# Access Compliance Report

## Public Rights-of-Way

Intersection ID: 14294	Main Street: EAST_BV	Cross Street: EUCLID_AV	Location: SW
ADA ID: DA18B0DFA839	Ramp Type: Directional1	Initial Pass/Fail: Pass	Overall Compliance: No
		Severity Score: 0

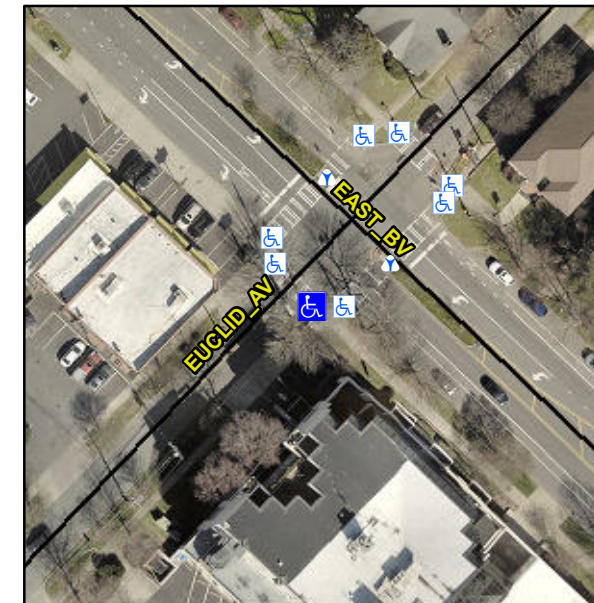
**Remove & Replace Entire Ramp.**

**Not Found, R304.2.2-Perp, R304.3.2-Para, R304.5.2**
